WOLF CREEK

May 2, 2007

ET 07-0011

Subject: Docket No. 50-482: Response to NRC Requests for Additional Information Related to Wolf Creek Generating Station License Renewal Application

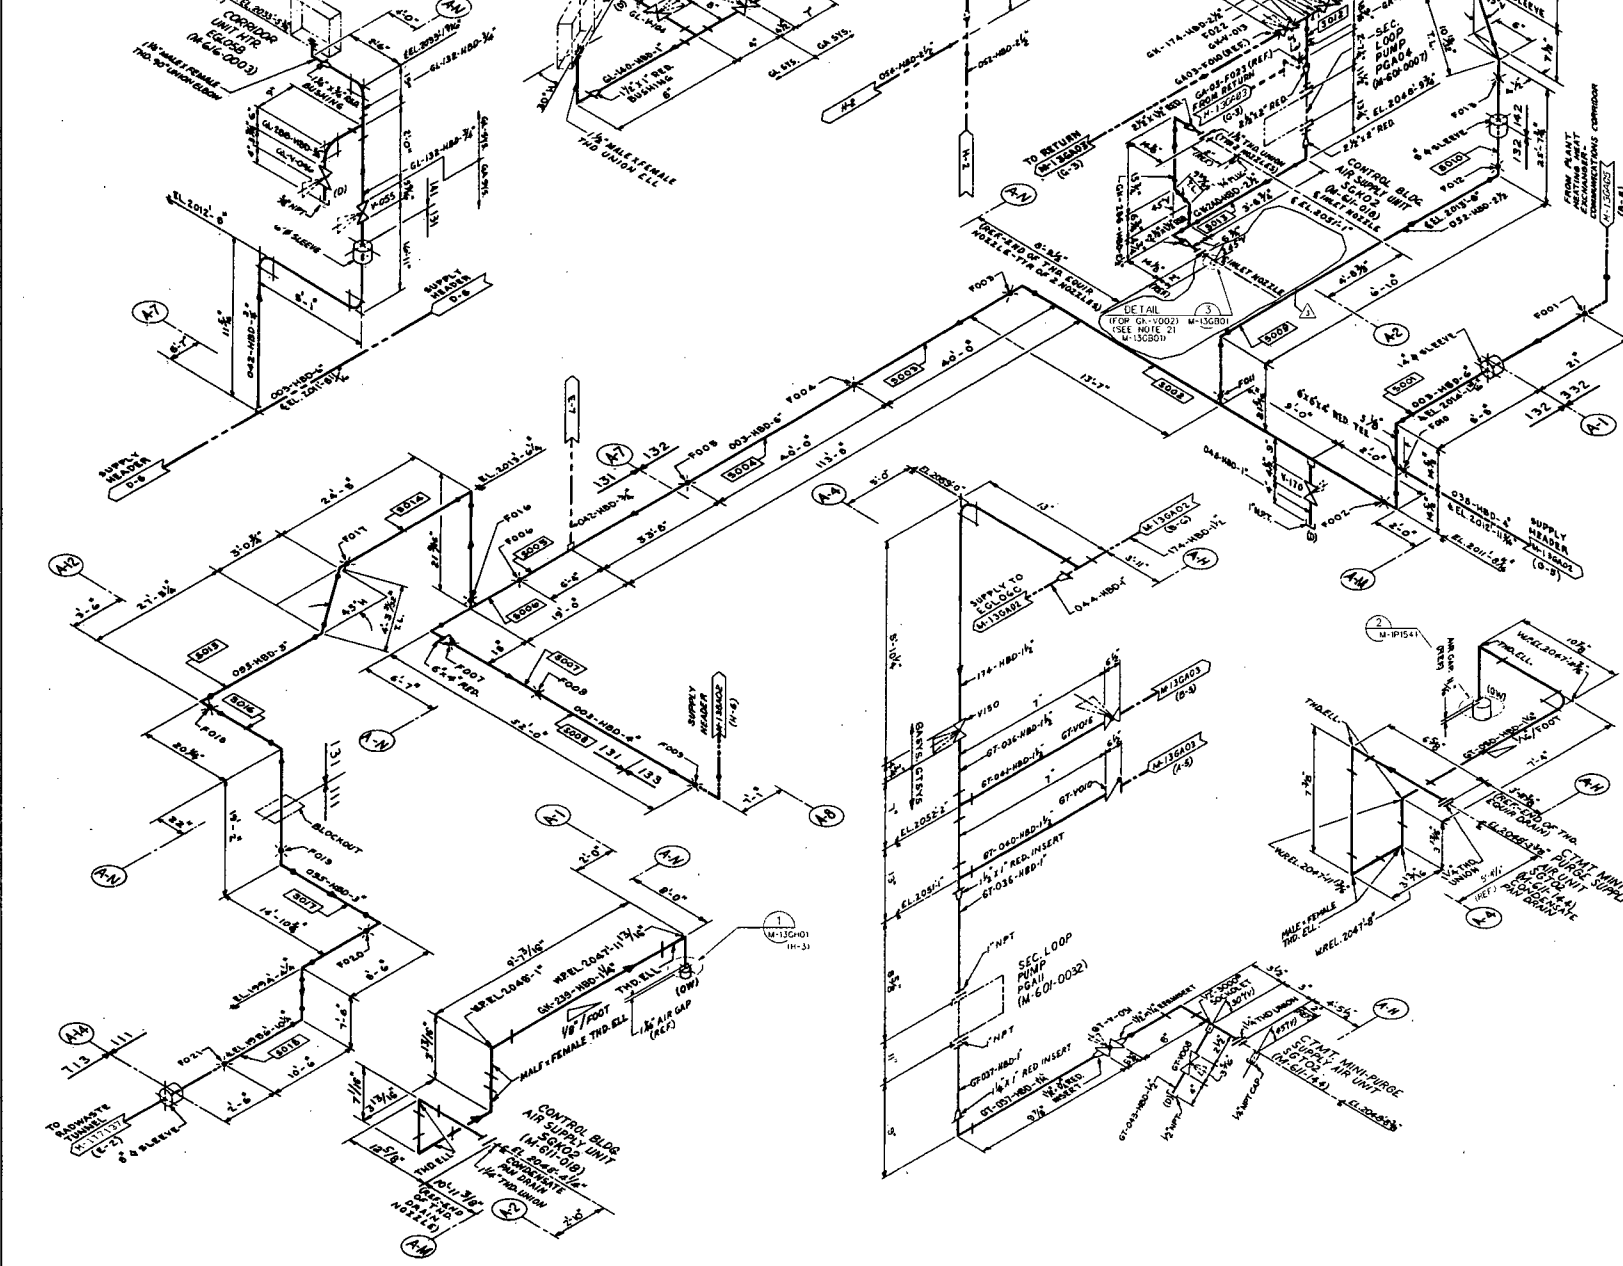
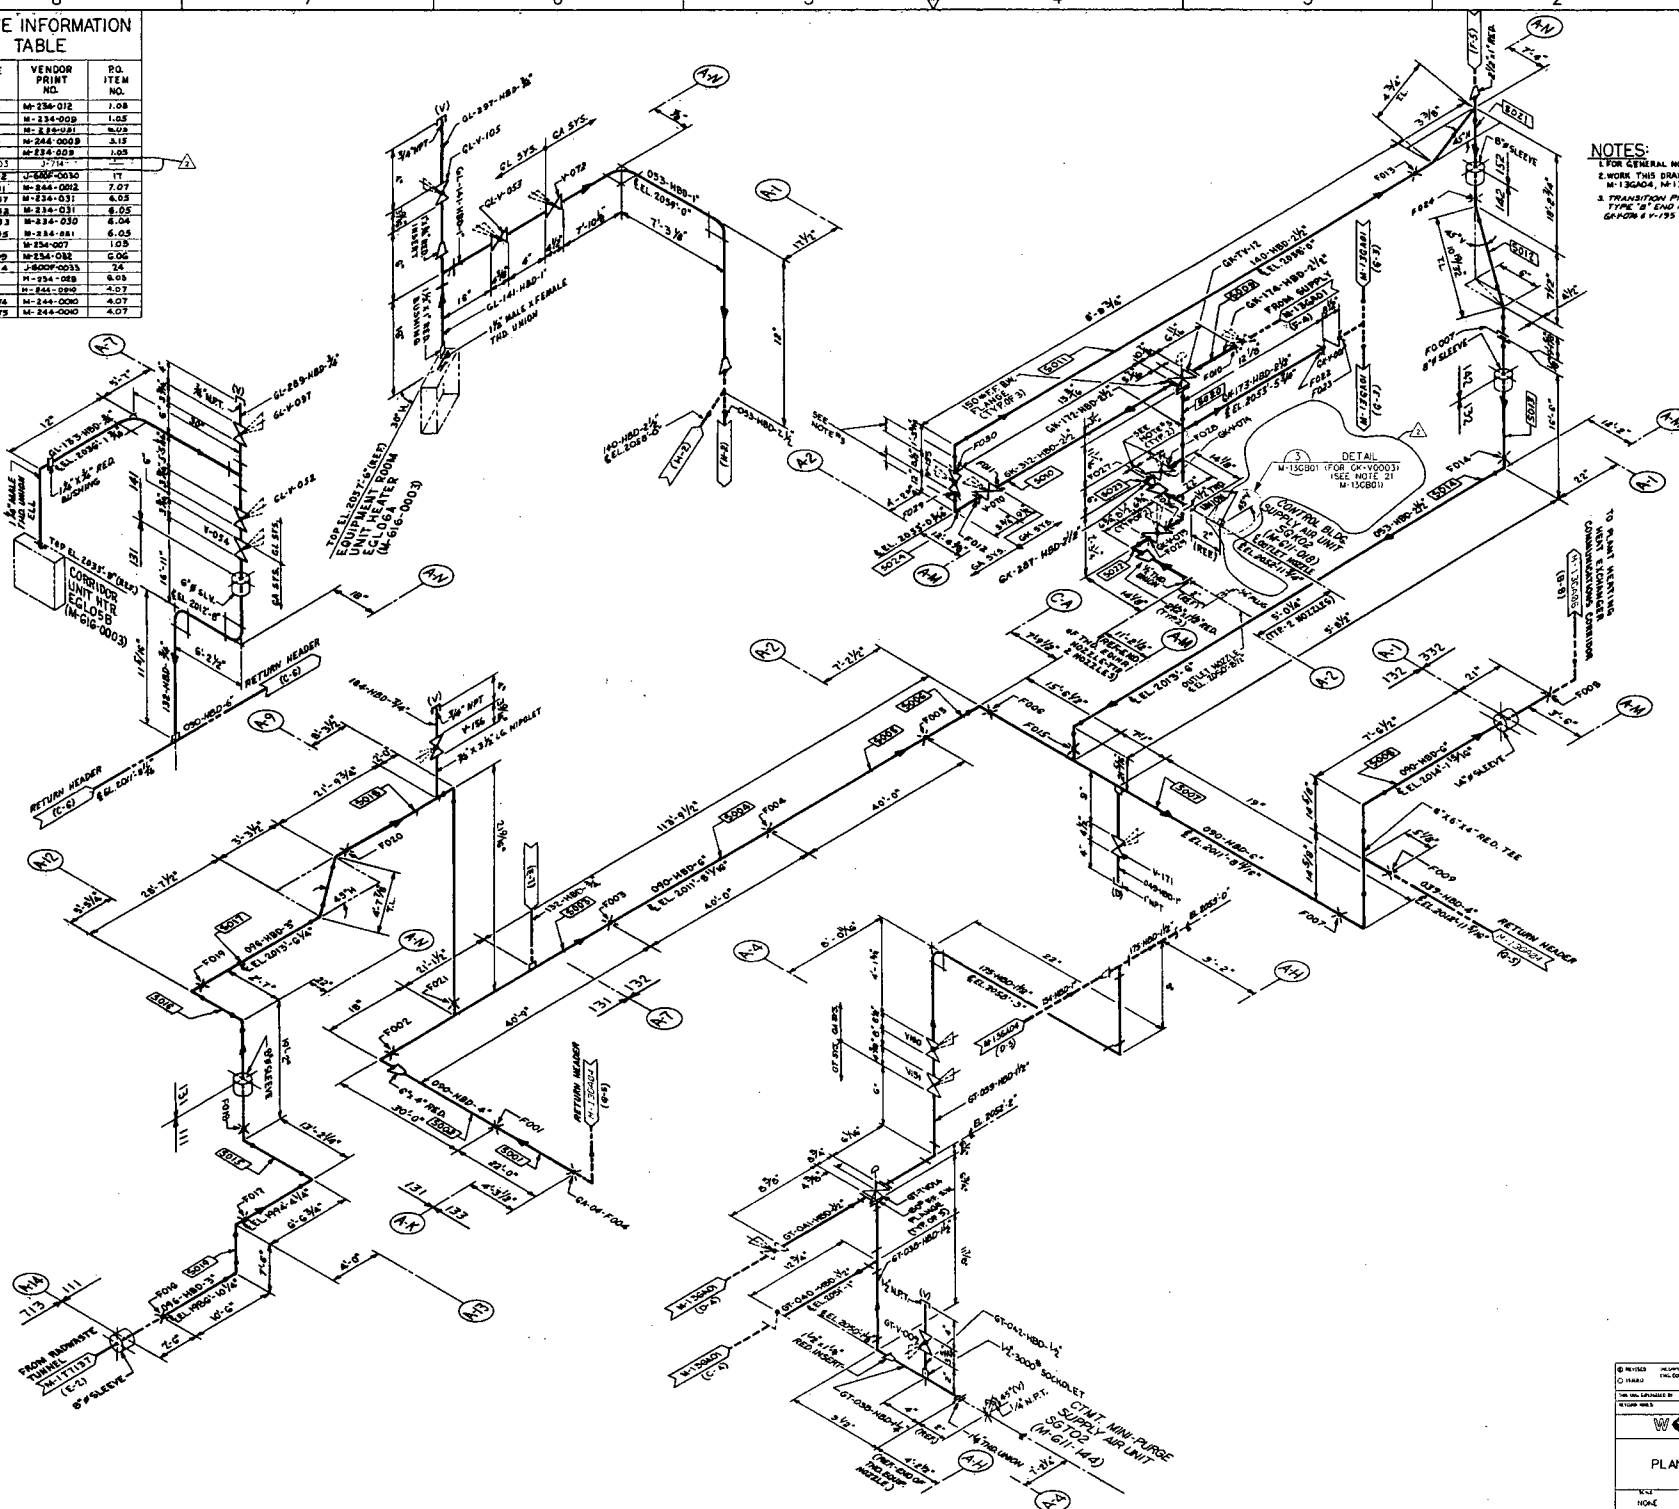
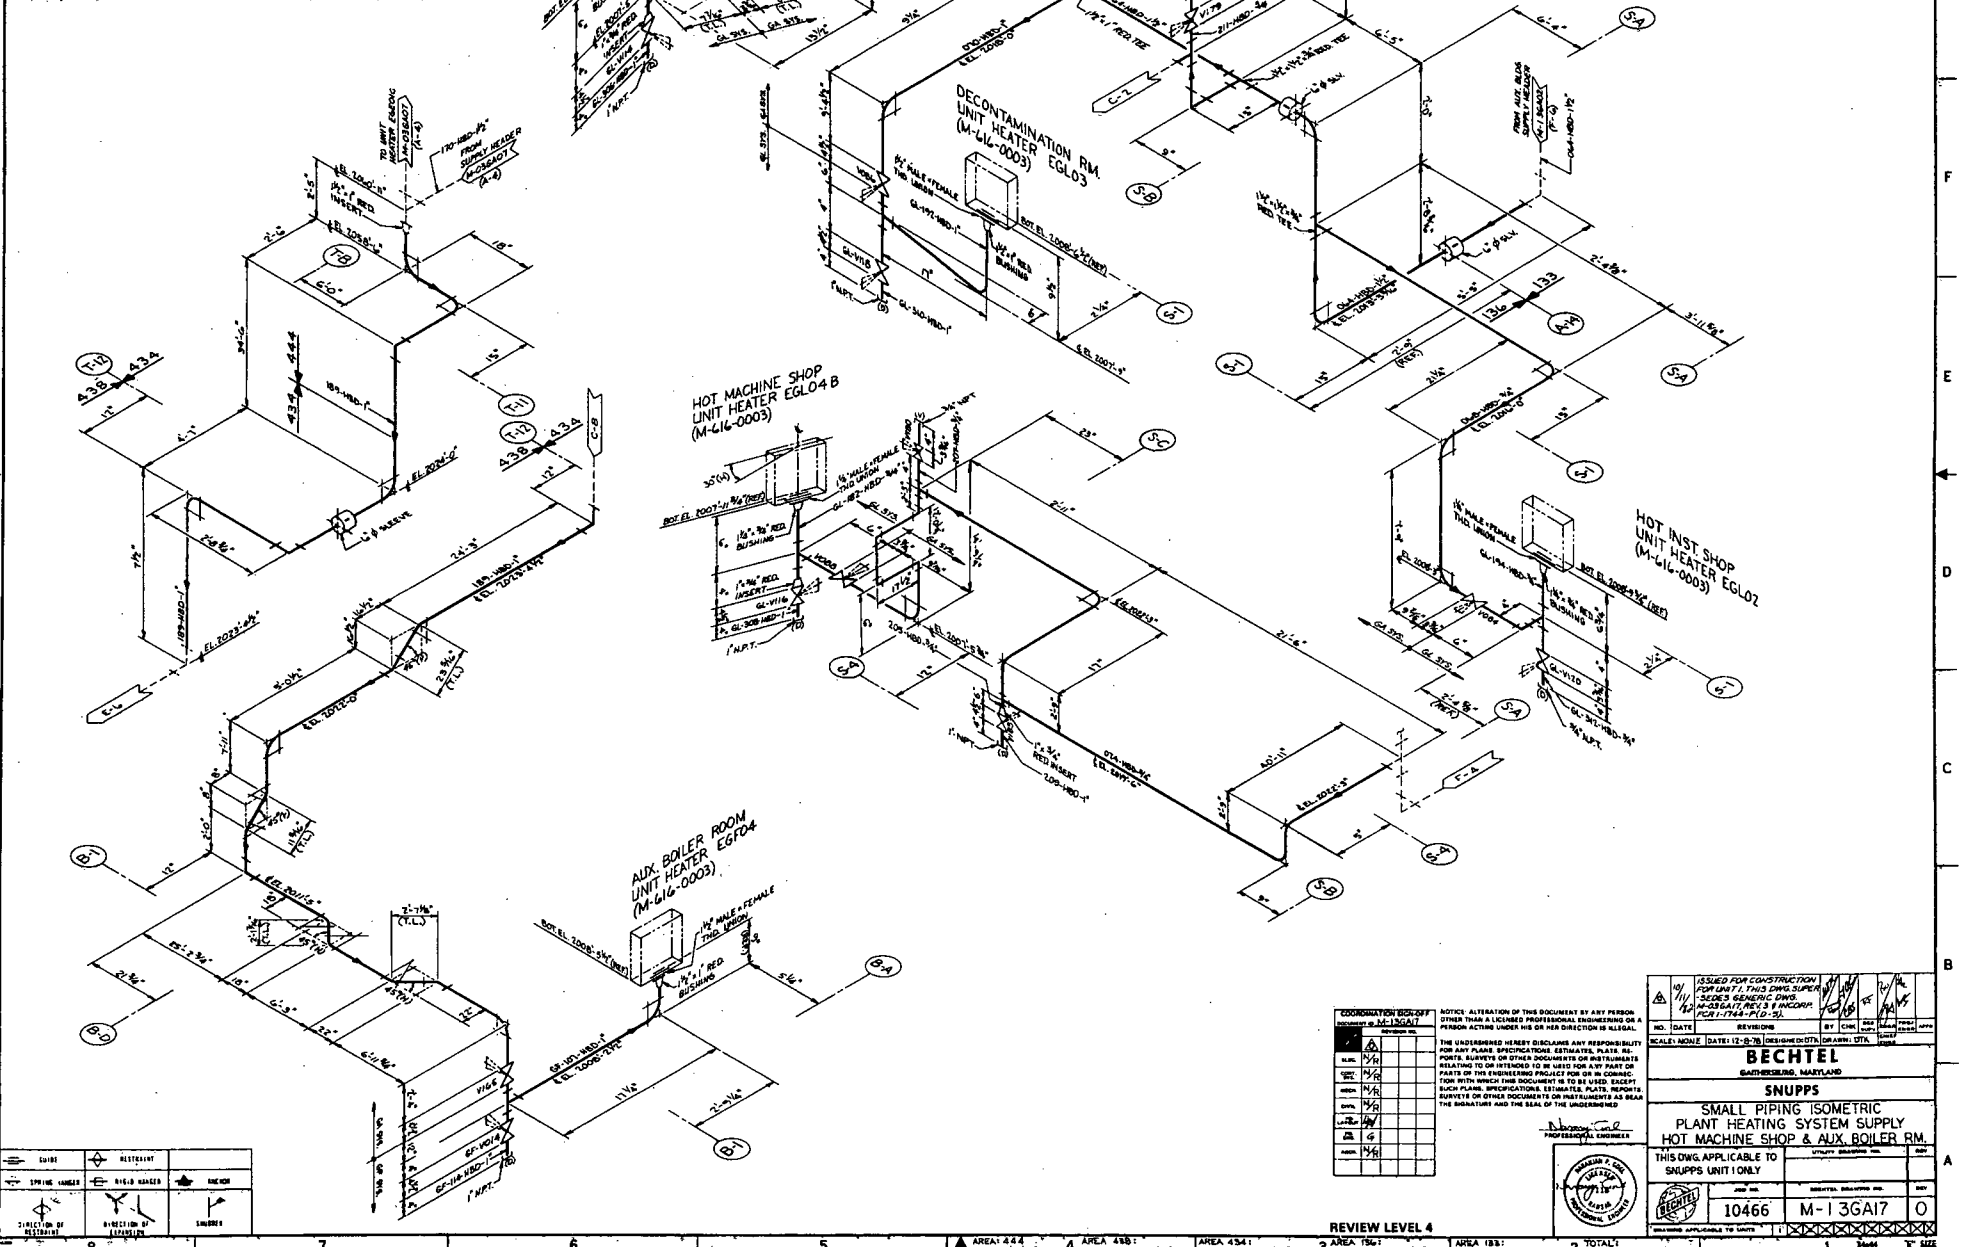
- (5) License renewal drawing LR-WCGS-GA-M-12GA02, for the plant heating system, shows system portions highlighted in red and ending with no further explanation. Additionally, references are made to drawings showing more detail of the boundaries, which are not included in the LRA. The staff requests that the applicant provide a description of the portions of the plant heating system that are within the scope of license renewal for meeting the requirements of 10 CFR 54.4(a)(2) due to spatial interaction. In addition, the staff requests that the applicant discuss the reason for terminating the scoping boundaries where indicated. In addition, the staff requests that the applicant provide the drawings referenced in LR-WCGS-GA-M-12GA02.

As shown on license renewal drawing LR-WCGS-GA-M-12GA02 plant heating system components are in the scope of license renewal for meeting the requirements of 10 CFR 54.4(a)(2) due to spatial interaction. Fluid filled plant heating system components have spatial interaction with safety related components in the auxiliary building, the control building and the fuel building.

Plant heating system piping lines GA095HBD-3 and GA096HBD-3 as shown on LR-WCGS-GA-M-12GA02 have spatial interaction termination points where fluid filled piping leaves the auxiliary building and enters the radwaste tunnel, which has no safety related equipment.

Plant heating system piping lines GA064HBD-1 ½ and GA065HBD-1 ½ as seen on LR-WCGS-GA-M-12GA02 have spatial interaction termination points where the fluid filled piping transitions from auxiliary building BLA (building, level, area) 133 to auxiliary building BLA 136, which contains no safety related equipment. The drawings referenced in LR-WCGS-GA-M-12GA02 for these piping lines have been provided in Enclosure 1.

Plant heating system piping lines GA003HBD-6 and GA090HBD-6 as shown on LR-WCGS-GA-M-12GA02 have spatial interaction termination points where the fluid filled piping transitions from the auxiliary building to the communications corridor, which, contains no safety related equipment. The drawings referenced in LR-WCGS-GA-M-12GA02 for these piping lines have been provided in Enclosure 1.
